LUMINARY Memo #83

To: Distribution
From: J. Kernan
Date: 19 May 1969
Subject: LUMINARY Revision 98

Setting of Word Order Bit in LUMINARY 98.

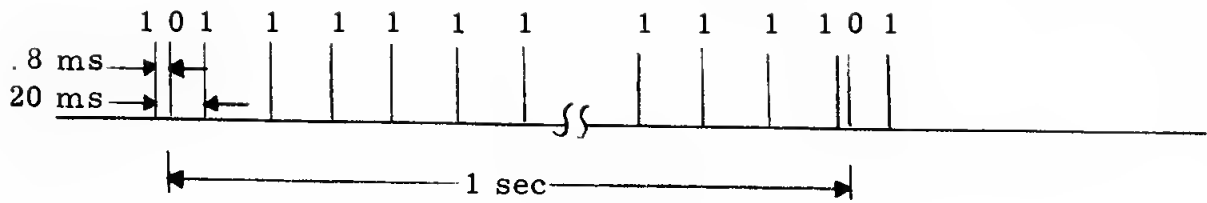
- 1) The coding to initialize the LAMBERT iteration counter (ITERCTR) was restored to INITVEL. See LUMINARY Anomaly 65. The counter is initialized to 20 D for coasting flight (Lambert targeting) or 5 for powered flight. This change affected Rope Module 2 (bank 11_g).
- 2) The Down-Telemetry program was changed to decrease the frequency at which it writes into output channel 13 bit 7 (the word order bit). In SUNDANCE and all previous revisions of LUMINARY, the write rate of the word order bit is 51 per second, fifty 1's and one 0. This change reduces the rate to twice per second, one 1 and one 0. The two writes are nominally separated by 19.2 milliseconds.
